### **Attachment 3 – Effect of Fully Penetrating Wells**

Attachment 3 Figure 3-2 NRC model-predicted potentiometric surface in Zone 2 with long-term operations at Selected Modules in Zone 3 and Zone 4 and fully penetrating wells LC19M and PW-102

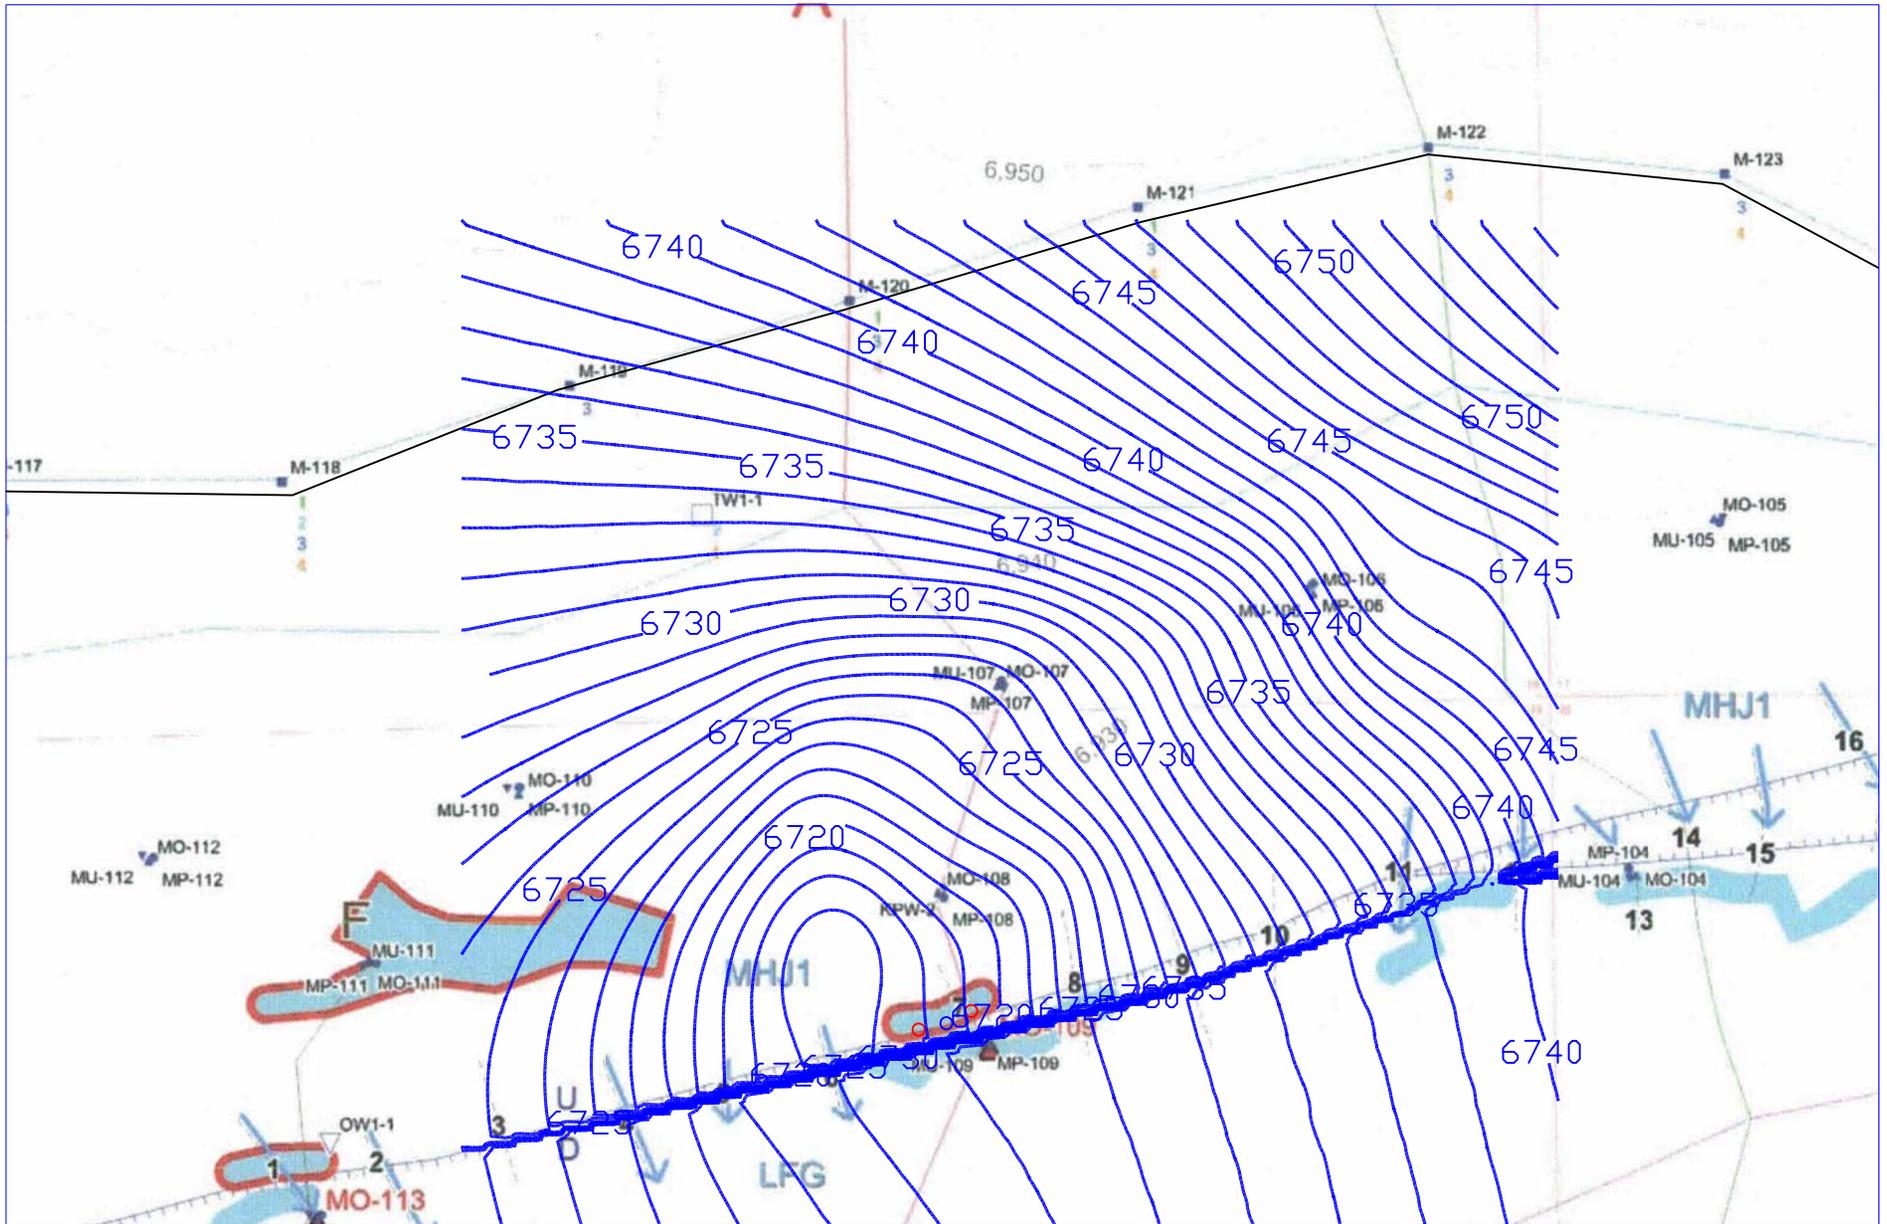
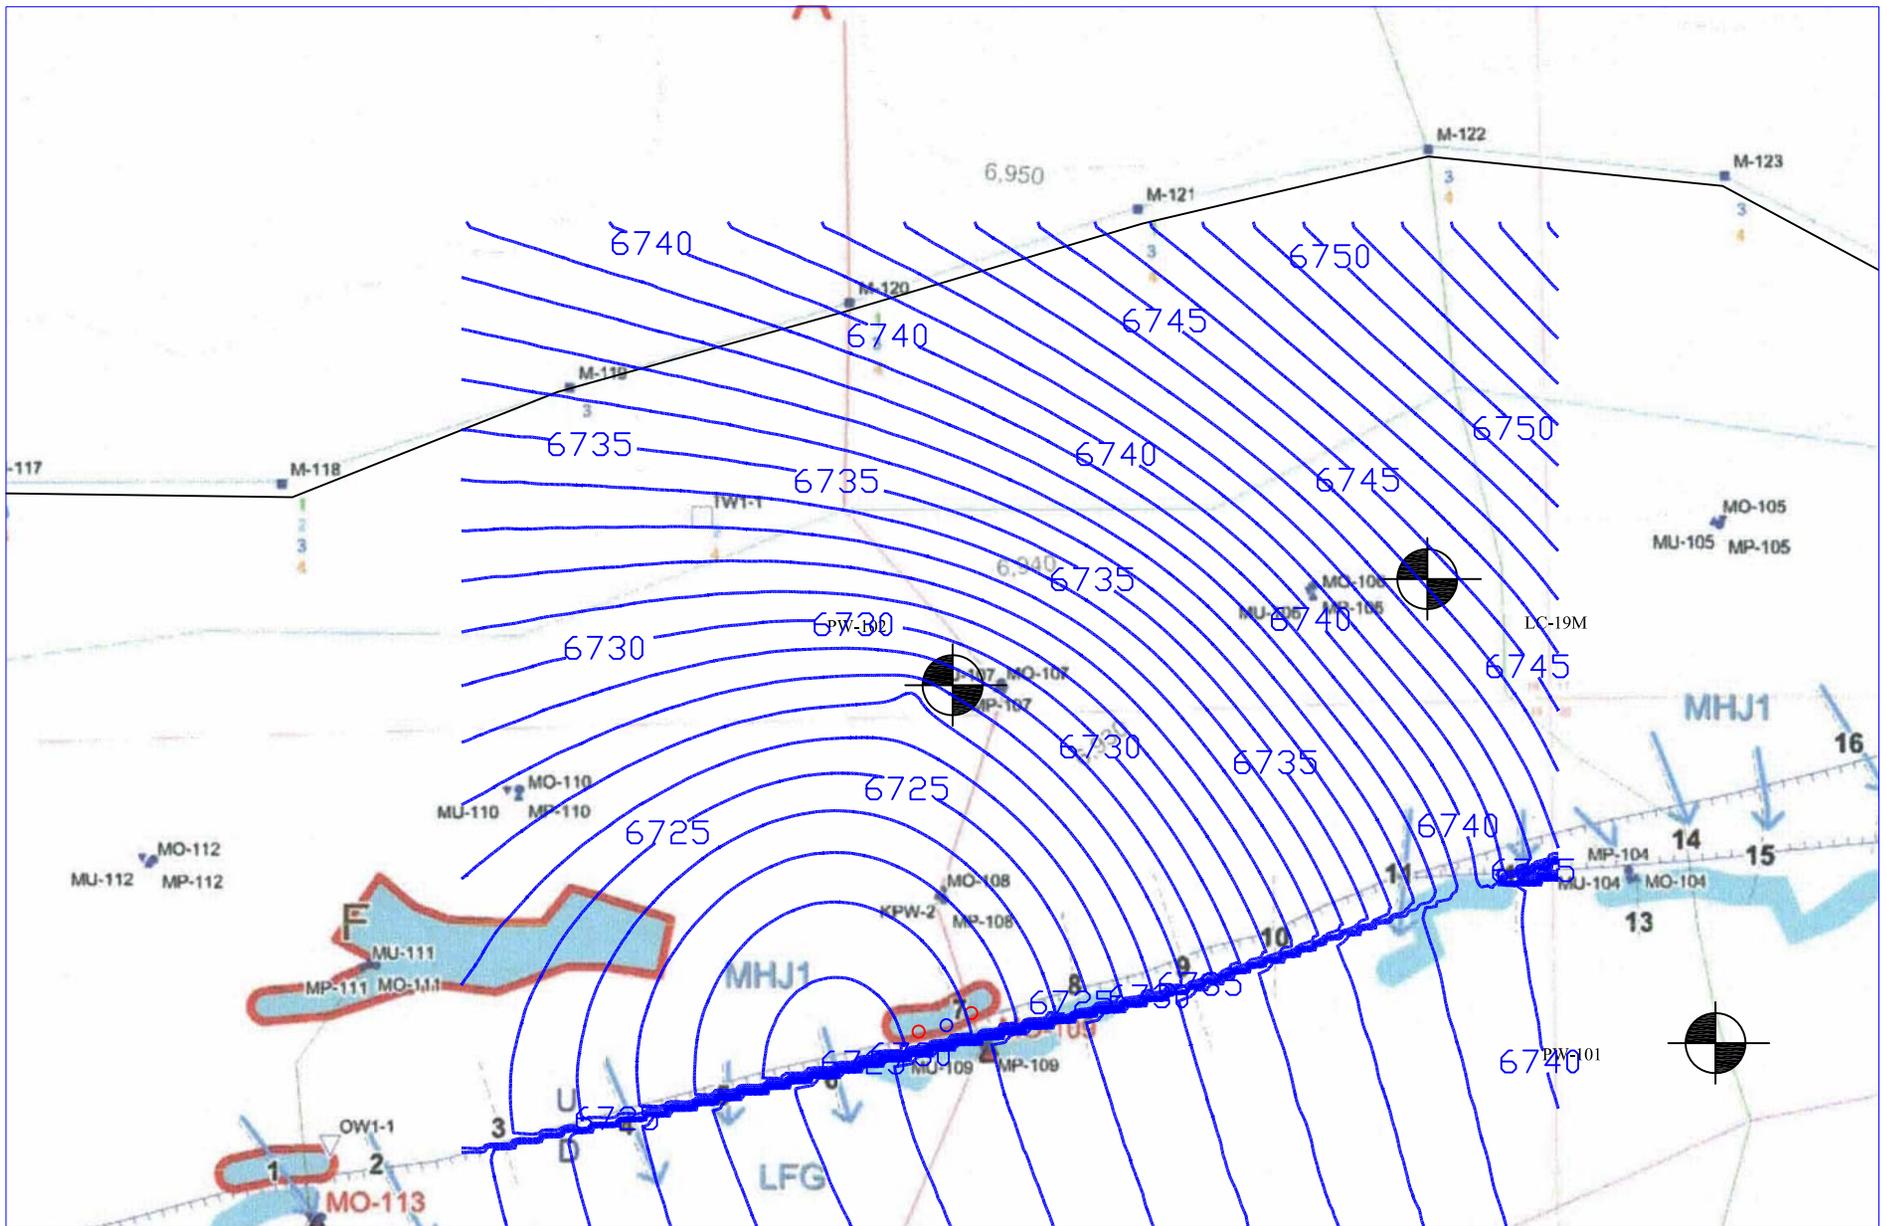
Lost Creek has made commitments to evaluate abandoned boreholes as potential conduits for lixiviant migration; however, staff is unaware of Lost Creek's plan for, or the extent of, all existing wells within the perimeter ring of MU1. Most wells appear to be screened in a single horizon. On the other hand, staff knows of at least four wells that are screened over multiple zones within the HJ horizon. Those wells are the pumping wells used to the regional and MU1 pumping tests (LC16M, LC19M, PW-101 and PW-102).

A comparison between Attachment figures 3-1 and 3-2 show area of minor depression in the vicinity of non-operating well PW-102. The minor depression indicates increased communication with Zone 3 through well PW-102. If well PW-102 was located closer to an injection well, the connection may result in the migration of lixiviant from Zone 3 to Zone 2.

Lost Creek does not propose monitoring, does not specify corrective actions should such a scenario develop nor provide details on well abandonment.
